LR-N07-0312

SALEM GENERATING STATION – UNIT 2
FACILITY OPERATING LICENSE NO. DPR-75
NRC DOCKET NO. 50-311

Subject: **RESPONSE TO REQUEST FOR ADDITIONAL INFORMATION,
INSERVICE INSPECTION PROGRAM RELIEF REQUESTS S2-I2-
RR-B01 AND S2-I2-RR-C01**

LR-N07-0312
Enclosure 3-1

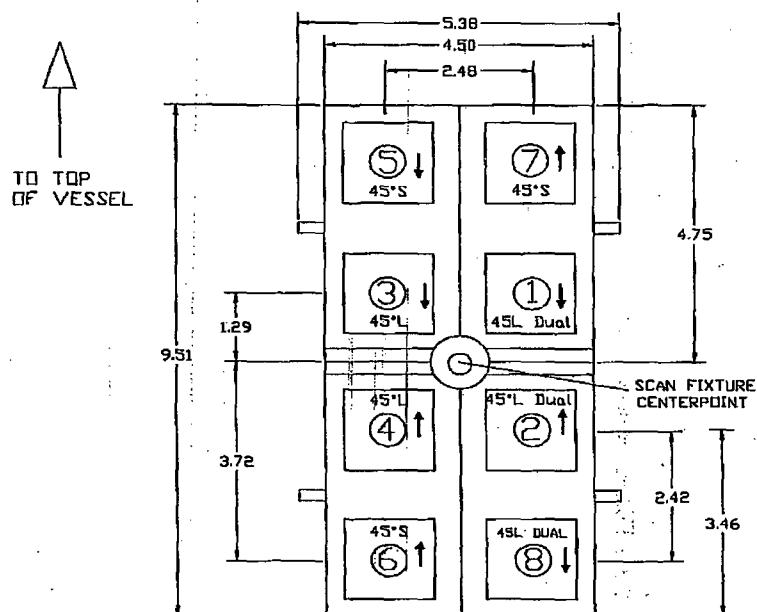
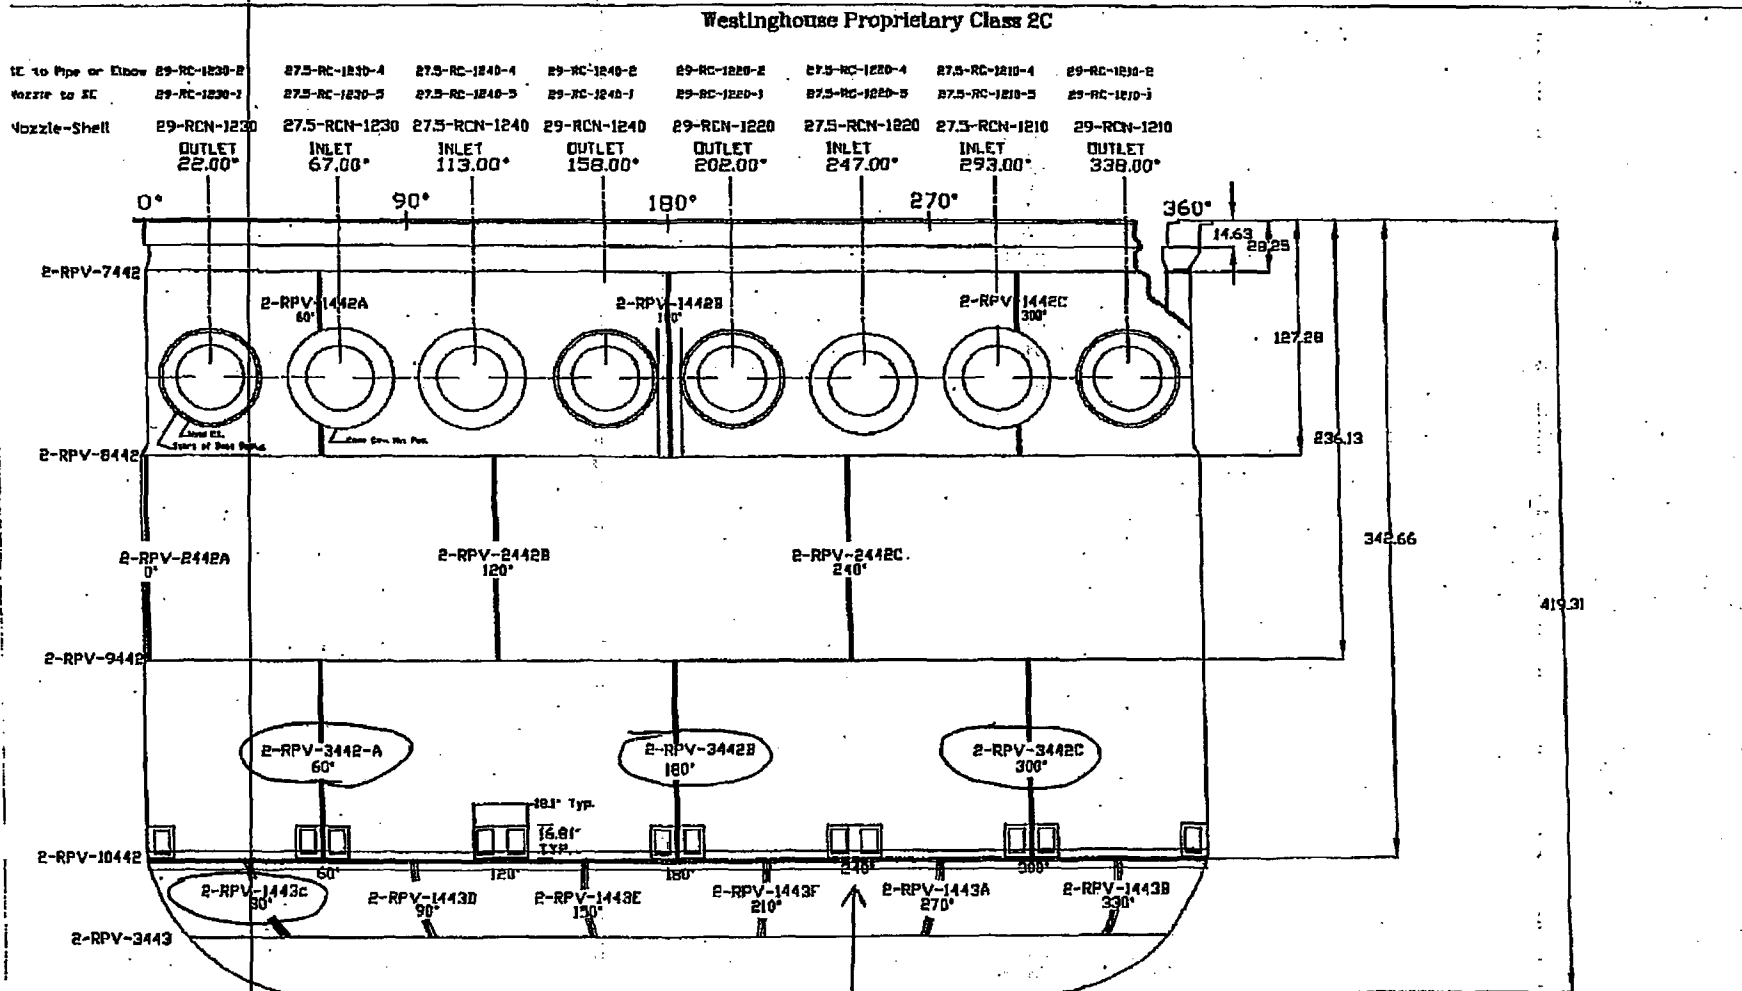
Weld 2-RPV-3442A is a longitudinal weld located at 60° azimuth on the lower shell course of the RPV, which was examined from the vessel interior. The transducer package used has external dimensions of 9.51" by 5.38" fixed to the examination tool by a center point mount (Reference Enclosure 3-1). The examination was limited at the lower end by core barrel lugs measuring 18.1" by 16.81" as depicted on the Vessel Rollout sketch included within the WesDyne International Examination Program Plan, Sheet 1 (Reference Enclosure 3-2). The extent of coverage was determined as depicted on the lower long seam (longitudinal weld) sketch included within the WesDyne International Examination Program Plan, Sheet 18 (Reference Enclosure 3-3); which clearly depicts the limitation caused by the core barrel lug. The weld coverage estimate was calculated to be 80.5%, as detailed on the WesDyne International R.V. Coverage Estimate Breakdowns calculation (Reference Enclosure 3-4). As is shown in Table 1-1, the actual coverage achieved was 81%, which closely matches the pre-examination estimate. Additional examination data for these welds was previously provided as Photo/Sketch Nos. 215, 215A, 215B, 216, 217, and 218 within Enclosure 1 to our June 27, 2007 letter (LR-N07-0150). PSEG believes that this explanation, supported by the enclosed four (4) additional sketches provides the necessary detail to support the request for relief for the limited coverage attained during examination of this weld.

dimensions of 9.51" by 5.38" fixed to the examination tool by a center point mount (Reference Enclosure 3-1). The examination was limited at the lower end by core barrel lugs measuring 18.1" by 16.81" as depicted on the Vessel Rollout sketch included within the WesDyne International Examination Program Plan, Sheet 1 (Reference Enclosure 3-2). The extent of coverage was determined as depicted on the lower long seam (longitudinal weld) sketch included within the WesDyne International Examination Program Plan, Sheet 18 (Reference Enclosure 3-3) which clearly depicts the limitation caused by the core barrel lug. The weld coverage estimate was calculated to be 80.5%, as detailed on the WesDyne International R.V. Coverage Estimate Breakdowns calculation (Reference Enclosure 3-5). As is shown in Table 1-1, the actual coverage achieved was 81%, which closely matches the pre-examination estimate. Additional examination data for these welds was previously provided as Photo/Sketch Nos. 215A, 215B, 219, 220, 221, and 222 within Enclosure 1 to our June 27, 2007 letter (LR-N07-0150). PSEG believes that this explanation, supported by the enclosed four (4) additional sketches provides the necessary detail to support the request for relief for the limited coverage attained during examination of this weld.

Enclosure 3-7

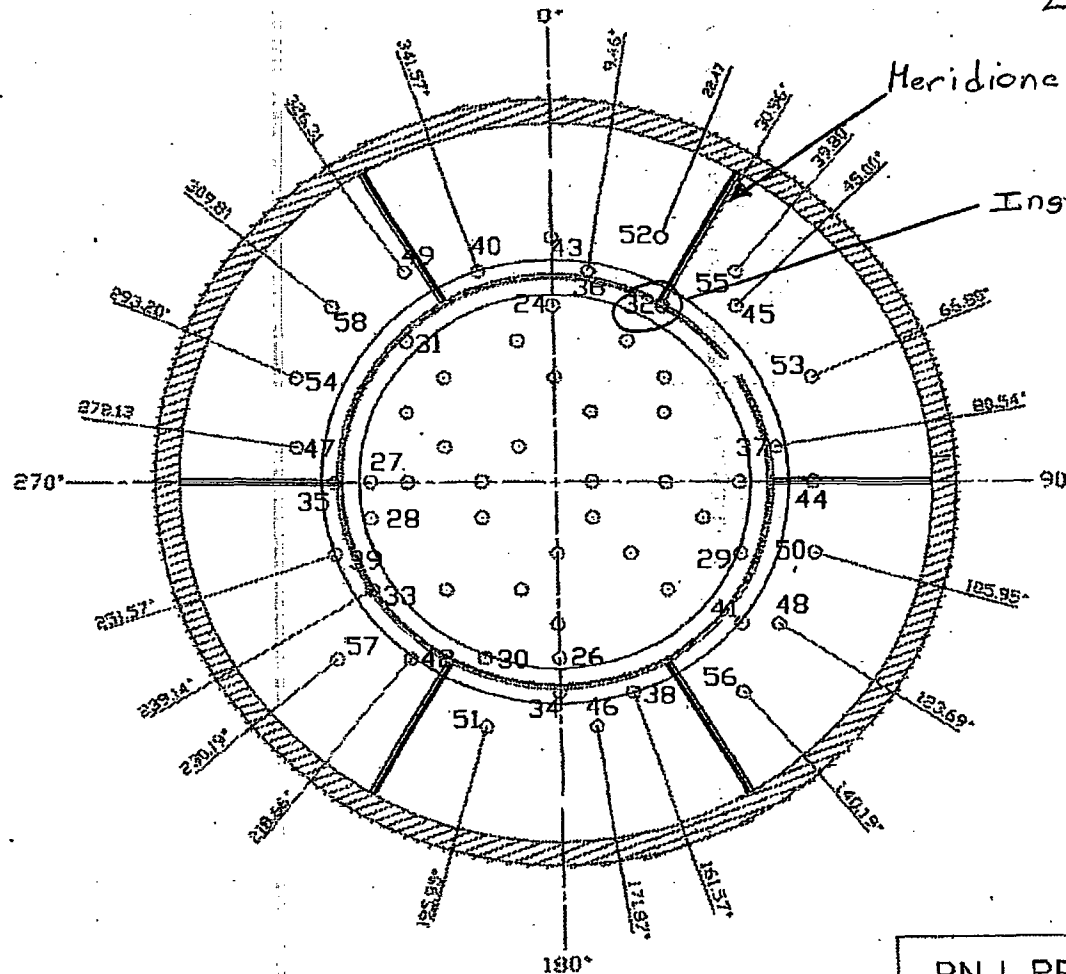
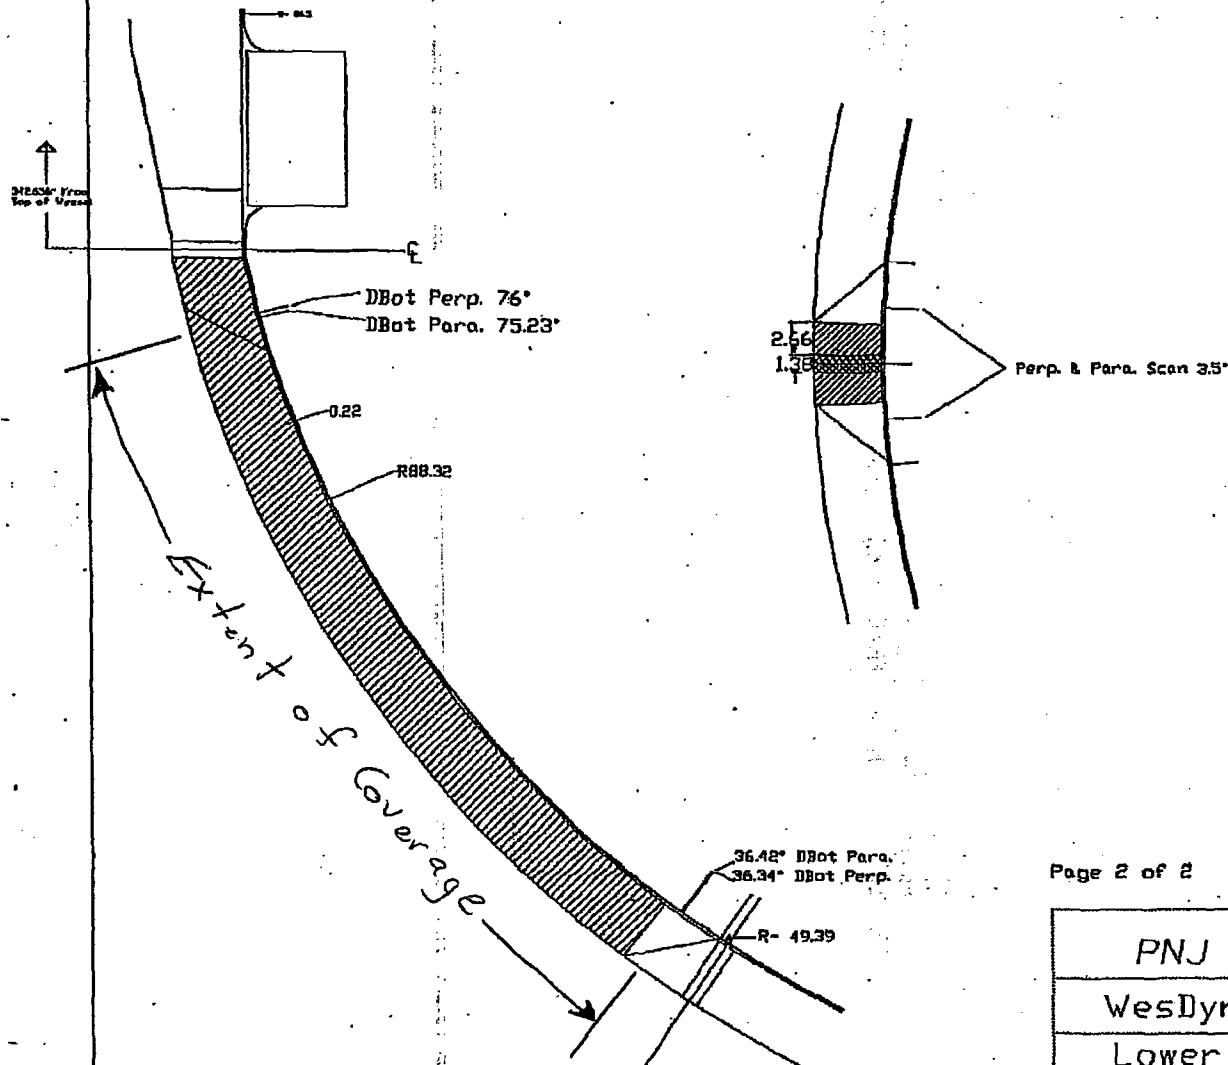
Weld 2-RPV-1443C is a meridional weld located at 30° azimuth on the bottom head of the RPV. The transducer package used has external dimensions of 9.51" by 5.38" fixed to the examination tool by a center point mount (Reference Enclosure 3-1). This examination was limited by

instrumentation tubes as depicted on the Bottom Head Dollar/Penetrations Sketch included within the WesDyne International Examination Program Plan, Sheet 1 (Reference Enclosure 3-7). The instrument tube that caused the examination limitation, has been identified by a circle (with the number 32) located at azimuth 30.96° on this sketch. The extent of coverage was determined as depicted on the lower head meridional sketch included within the WesDyne International Examination Program Plan, Sheet 21 (Reference Enclosure 3-8). The weld coverage estimate was calculated to be 88.18%, as detailed on the WesDyne International R.V. Coverage Estimate Breakdowns calculation (Reference Enclosure 3-9). As is shown in Table 1-1, the actual coverage achieved was 88%, which closely matches the pre-examination estimate. Additional examination data for these welds was previously provided as Photo/Sketch Nos. 232, 233, 234, 235, and 236 within Enclosure 1 to our June 27, 2007 letter (LR-N07-0150). PSEG believes that this explanation, supported by the enclosed four (4) additional sketches provides the necessary detail to support the request for relief for the limited coverage attained during examination of this weld.
